PC Case# PC25-05	Date Received: 7/8/2025
Reviewed By: ES	PC Meeting Date: 8/25/2025
Council Meeting Date: 9/18/2025	Date of Legal Publication: 8/13/2025
Fee: \$ 1,080.00	<input type="checkbox"/> Cash <input type="checkbox"/> Credit Card <input checked="" type="checkbox"/> Check # 21277

RE: Review of Final Plan / Construction Drawings
Northwood Estates Subdivision – Section 1

The Kleingers Group has reviewed the Final Plan / Construction Drawings for Northwood Estates Subdivision Section 1 by Choice 1 dated July 7, 2025 and have the following comments/observations:

R E: REQUEST FOR A PRELIMINARY & FINAL SUBDIVISION PLAN FOR NORTHWOOD ESTATES SECTION 1 SUBDIVISION

SHEET NUMBER
13 OF 19

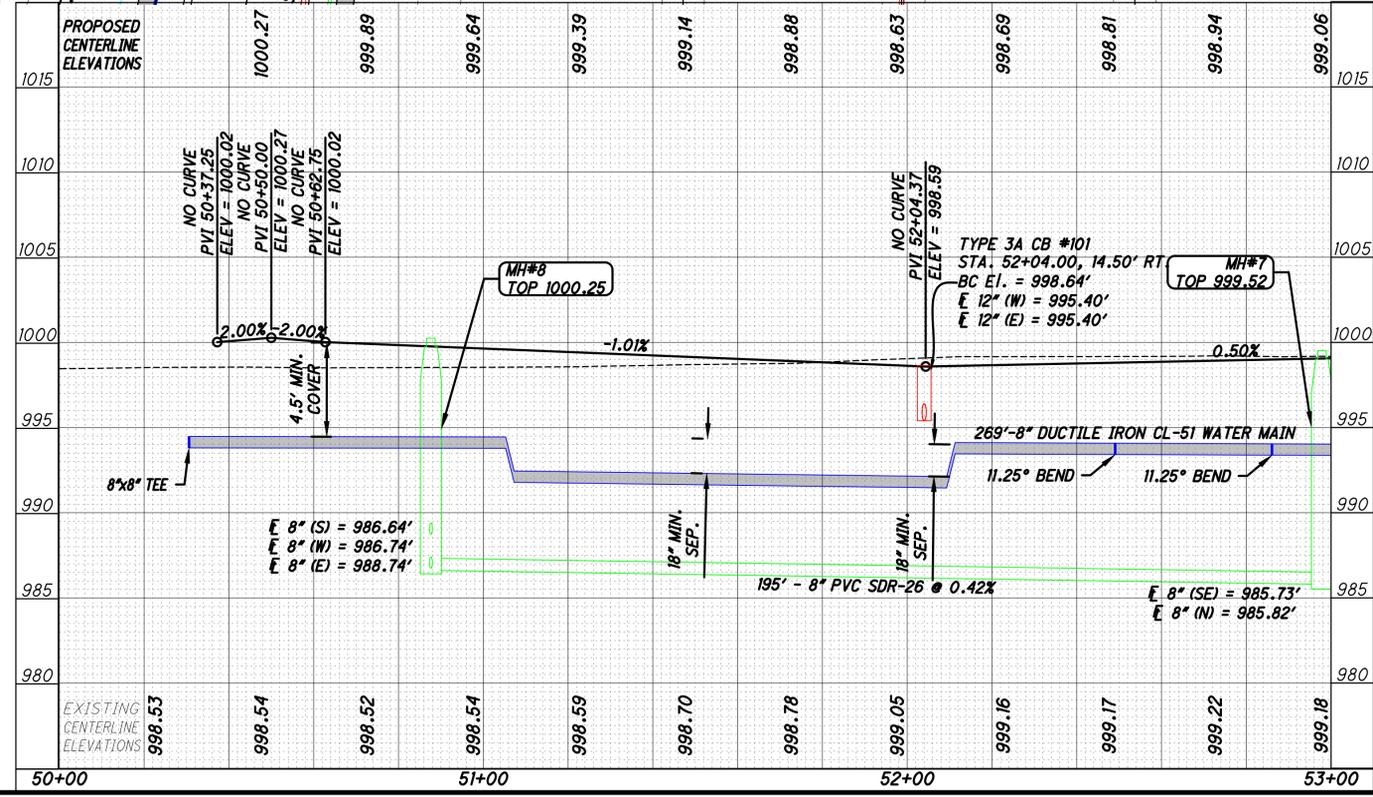
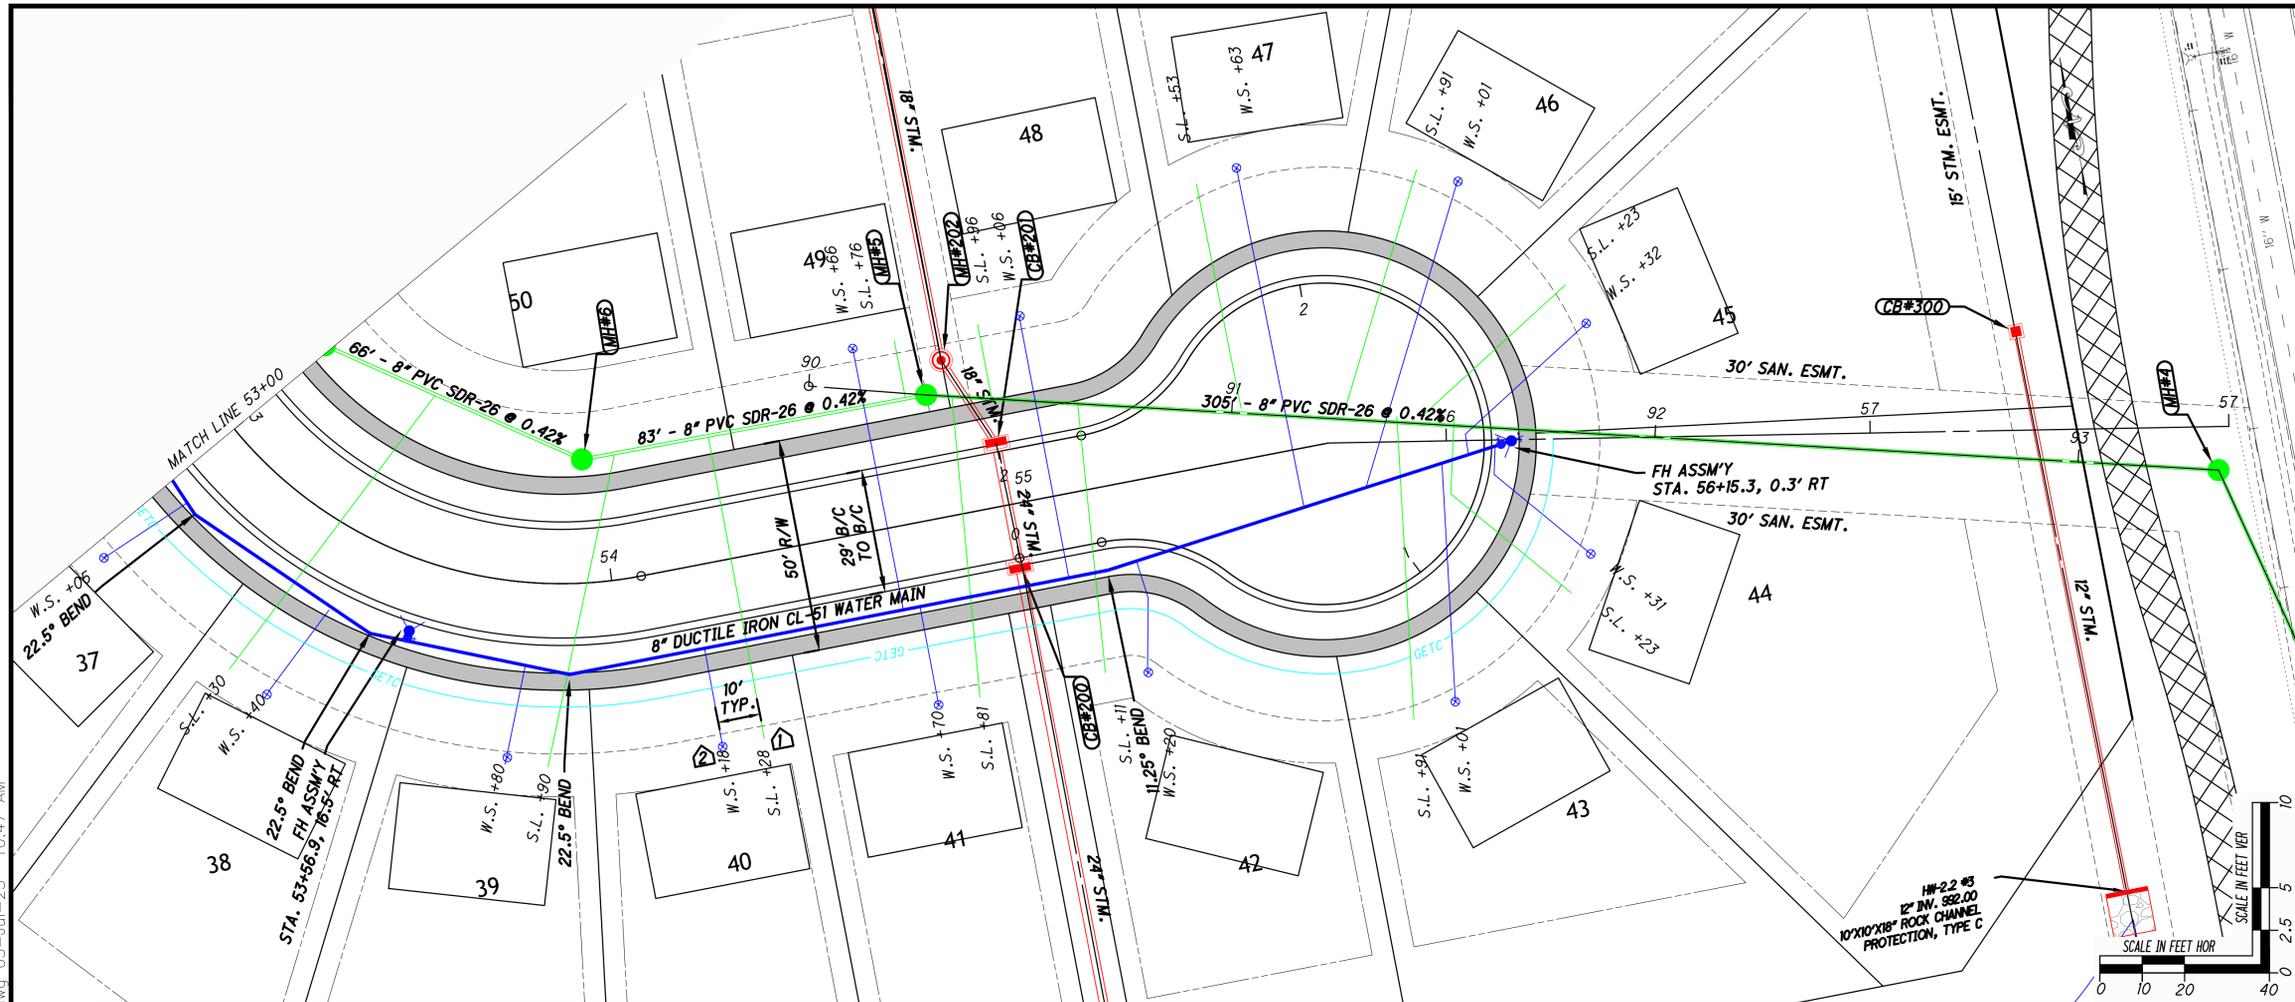
23. Extend the walk on either side of Stillwater Way to match the width of multi-use path.
24. Align services for Lot 50 with the building pad.
25. Water main on sheet 13 for Bolt Court shows it dipping to have 18" separation, but nothing is shown on the profile.

REVISIONS:	
FILE NAME	GP001
DRAWN BY	KMM
CHECKED BY	NNS
PROJECT No.	MOTCLA2504
DATE	7-7-2025
SHEET NUMBER	14 OF 19

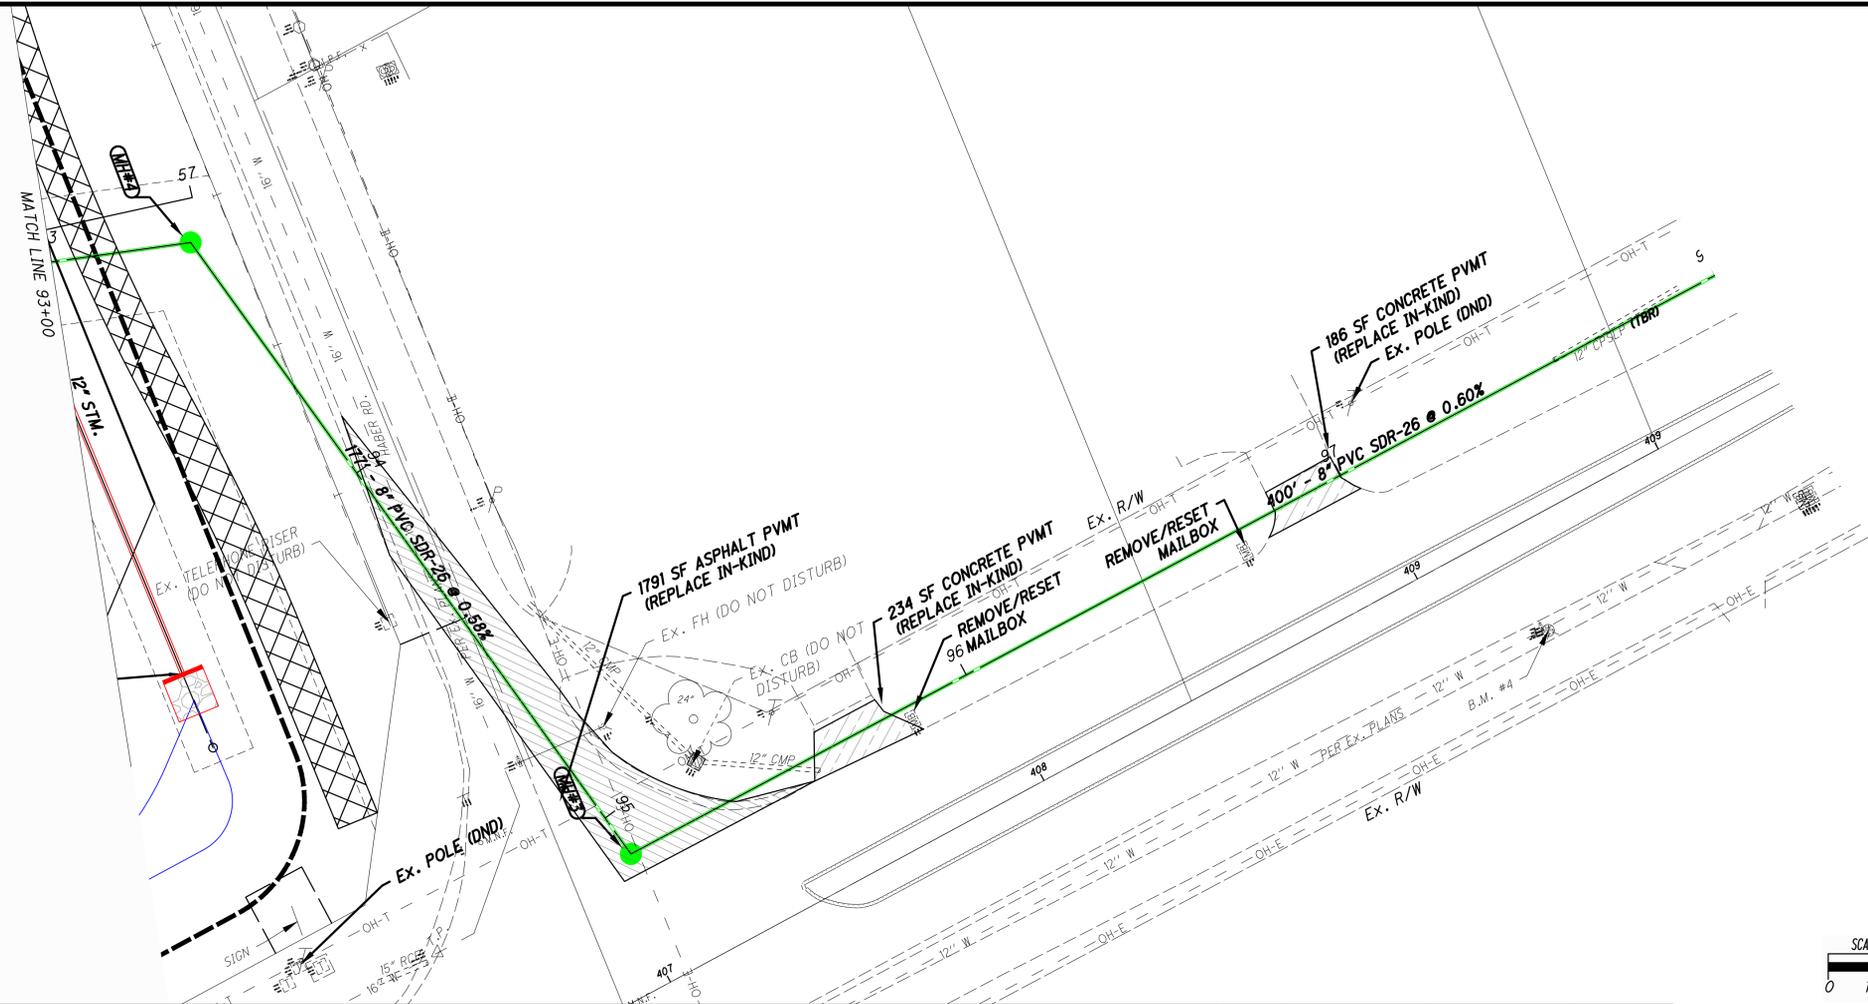
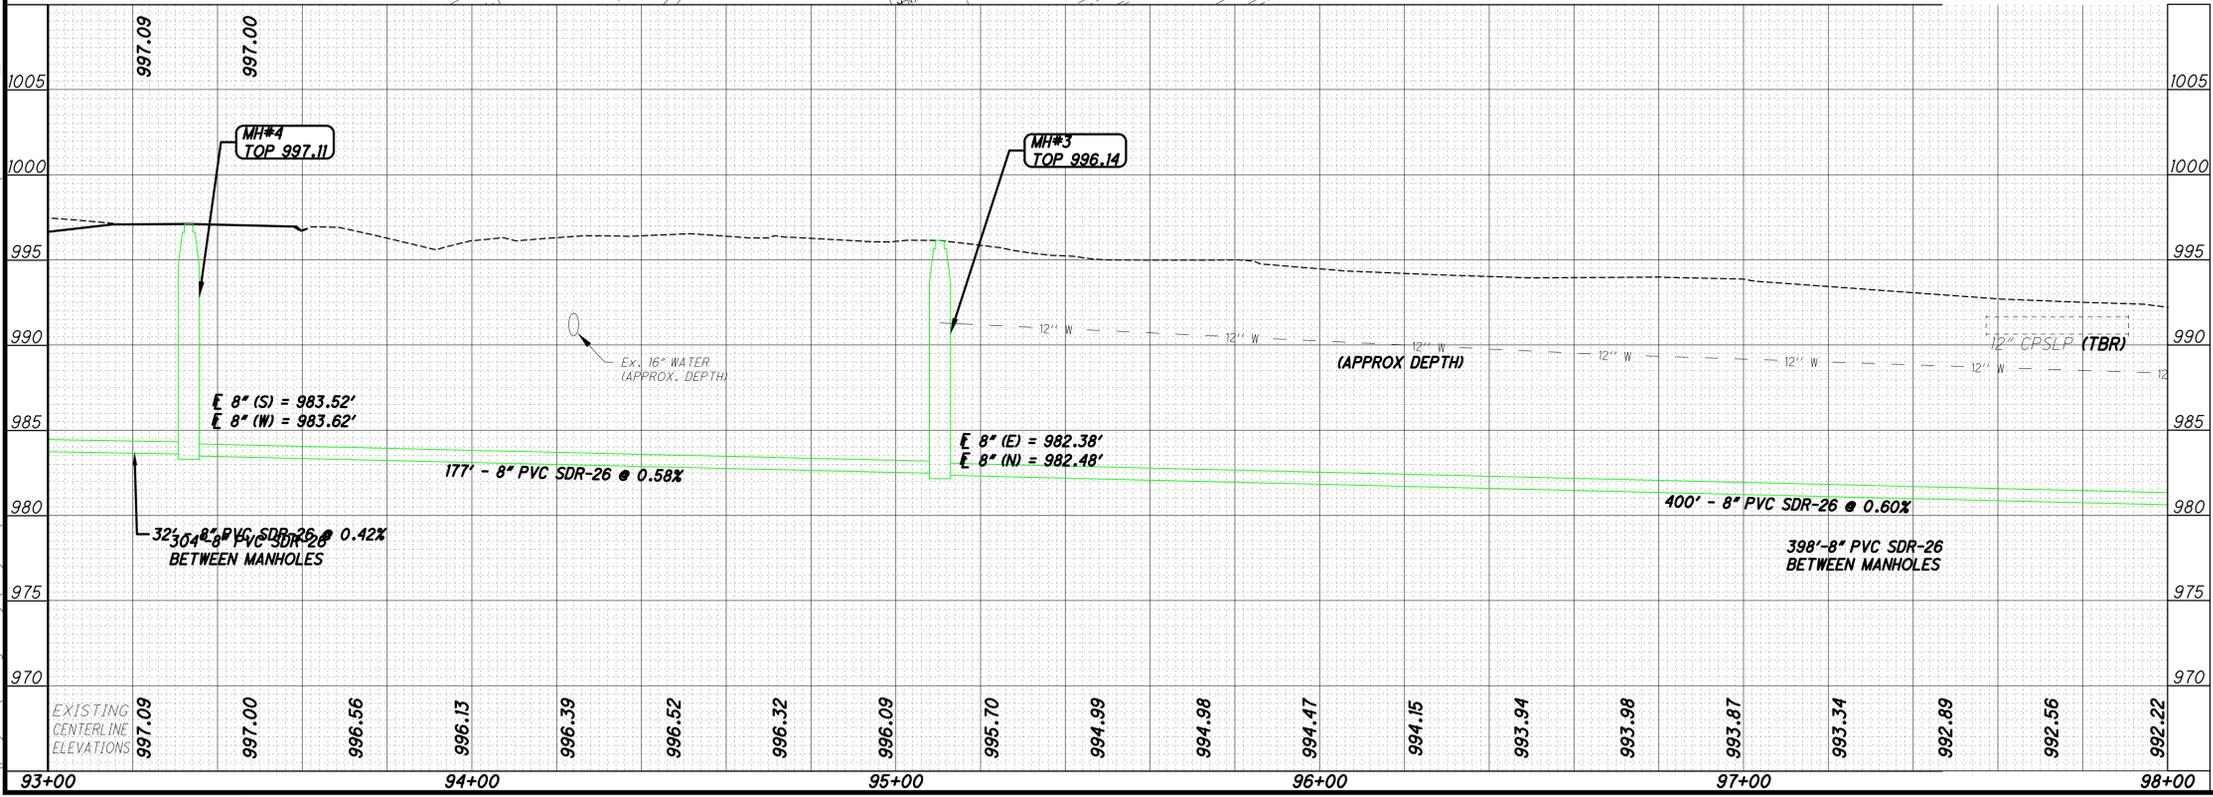
26. Move the North Arrow out of the hatching on sheet 14.
27. Move the Fire Hydrant out of the Sanitary Sewer easement on Bolt Court cul-de-sac.
28. There are 2 points labeled as Station 104 on Page 17.

PROP. RETENTION BASIN
TOP 996.00
BOTTOM 992.00
NON-REAR FILTER ELEVATION 993.00
5'-REAR CRITICAL STORM ELEVATION 994.02

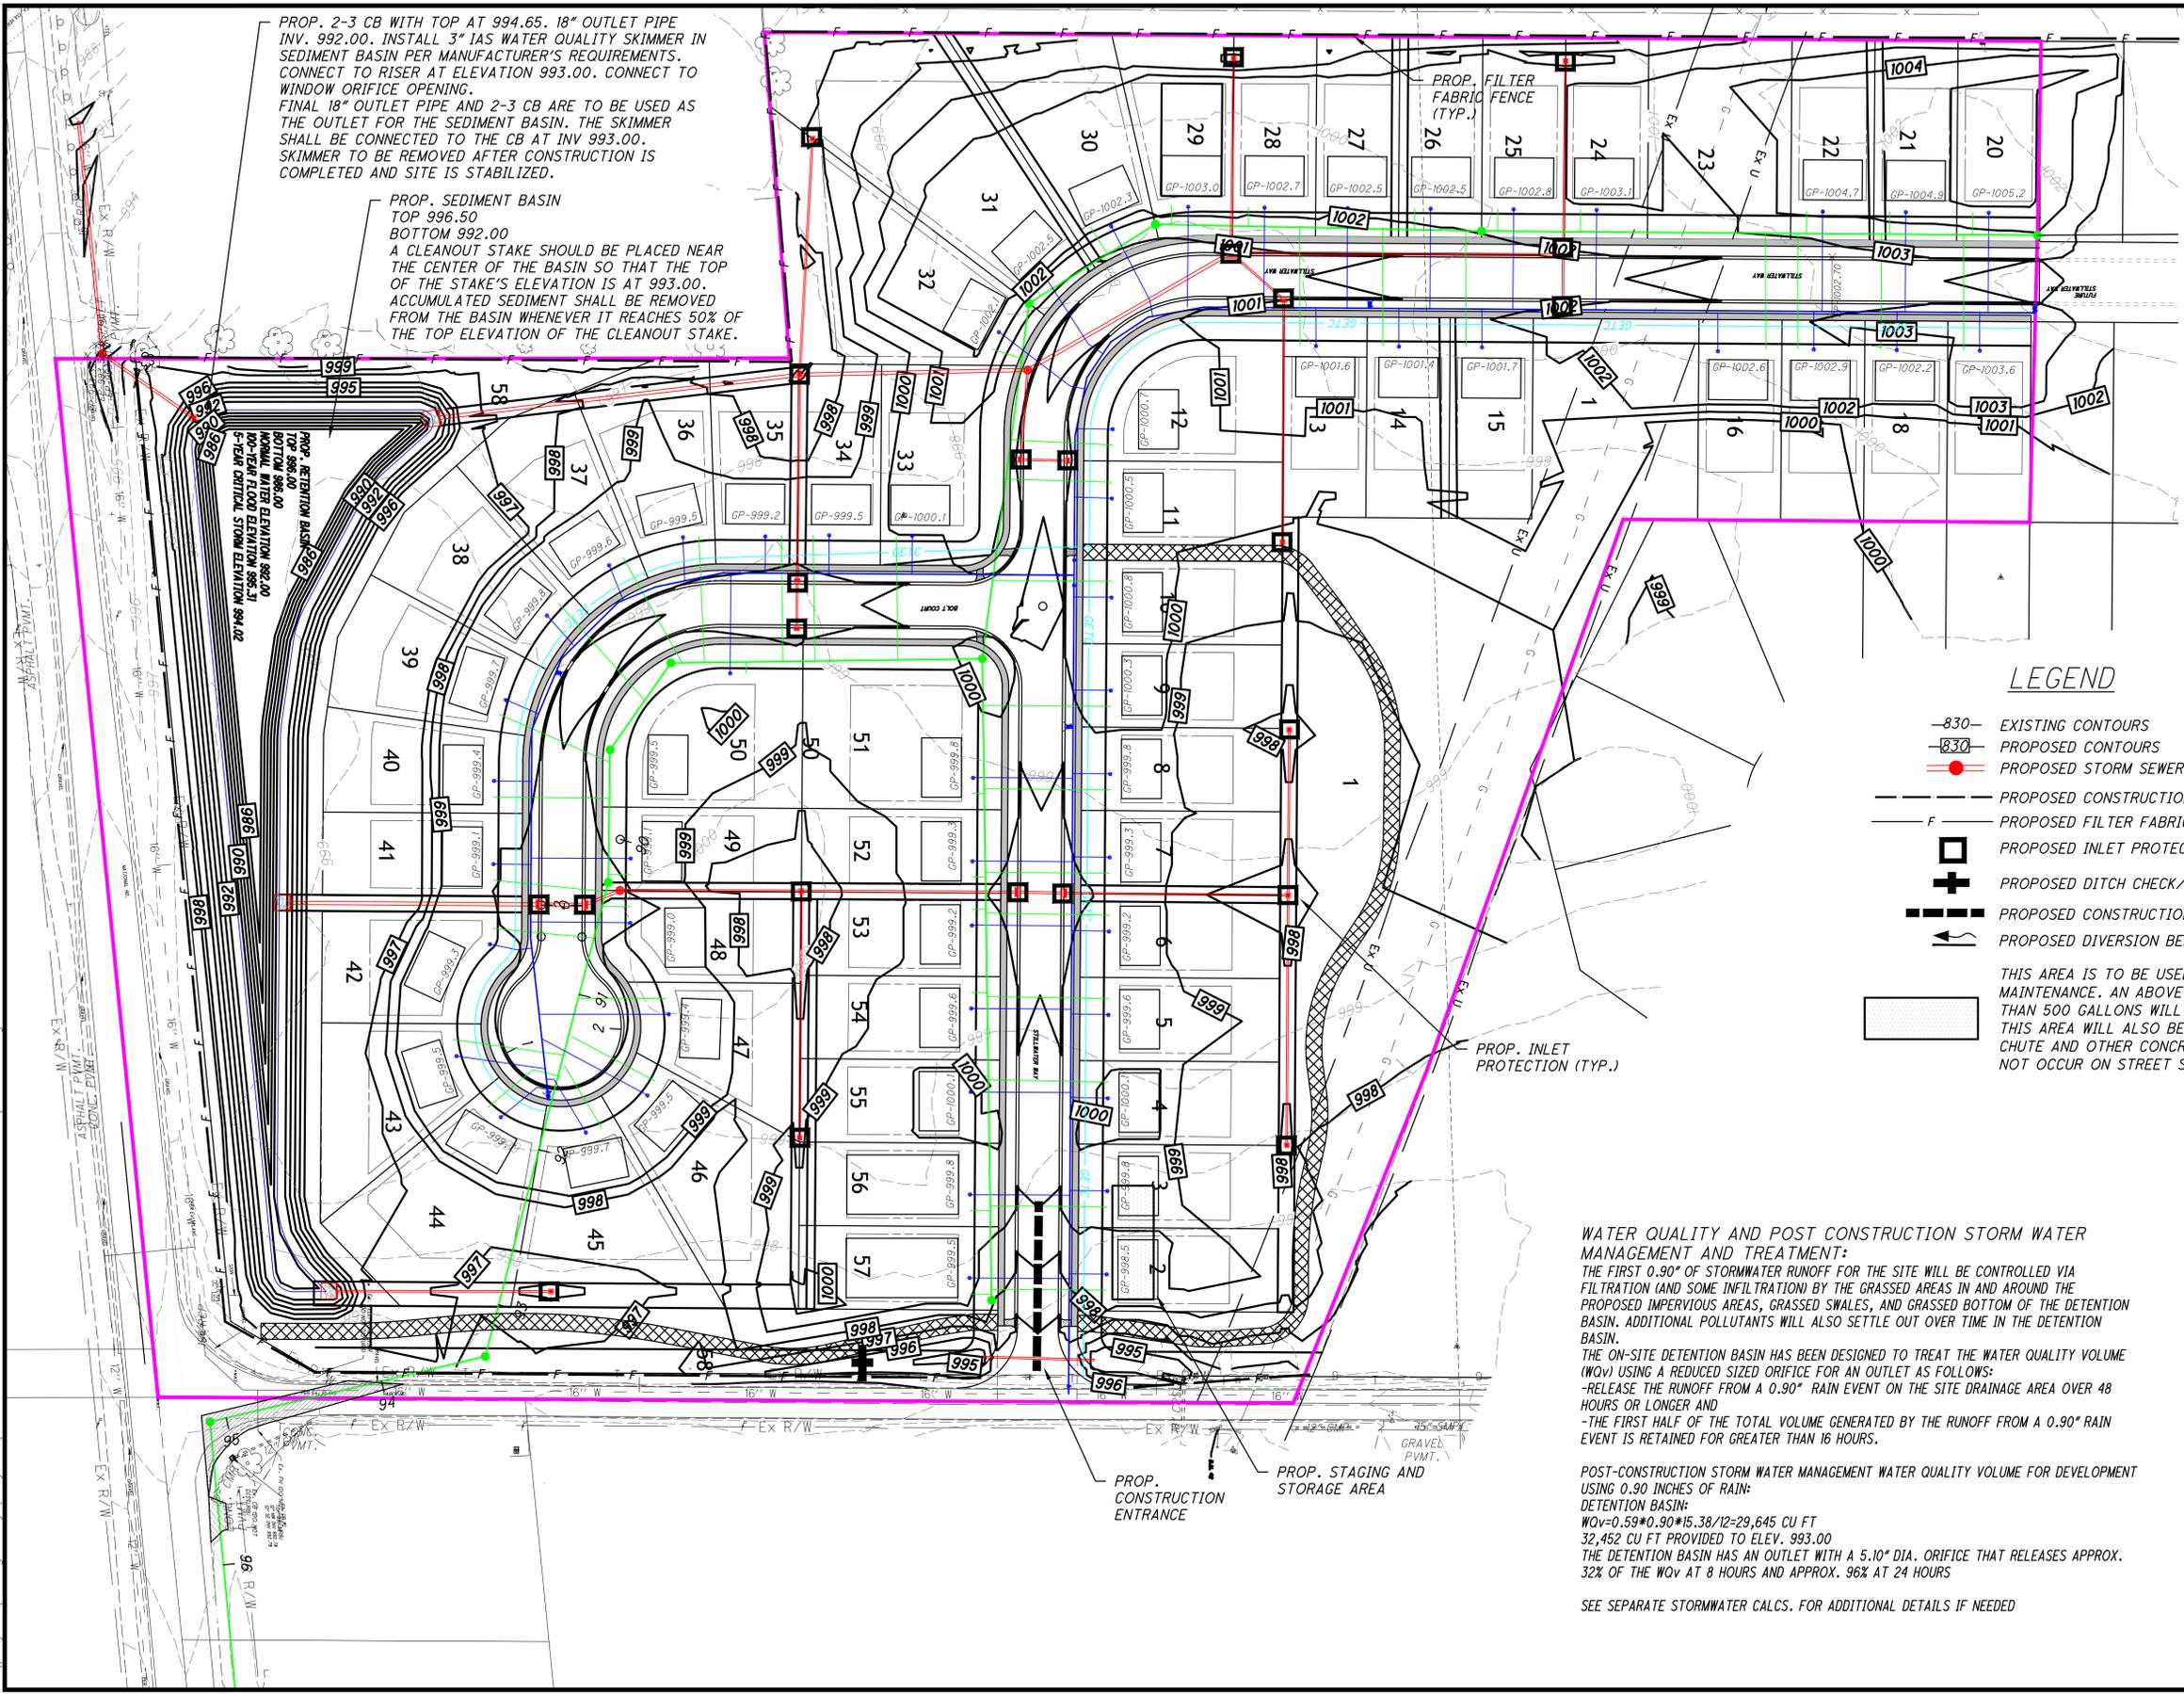
34. Provide an area calculation of the water area of the retention basin showing that it is at least ½ acre.
35. Provide a typical profile of the retention basin showing a safety ledge four to six feet in width approximately thirty to thirty-six inches below the permanent water level and a 5-foot berm at 2% slope beginning at least one foot above normal pond elevation. The slope between the two ledges should be stable and of a material which will prevent erosion due to wave action. Side slopes above the berm shall be 3 to one or flatter. Side slopes of the pool shall be two to one or flatter.
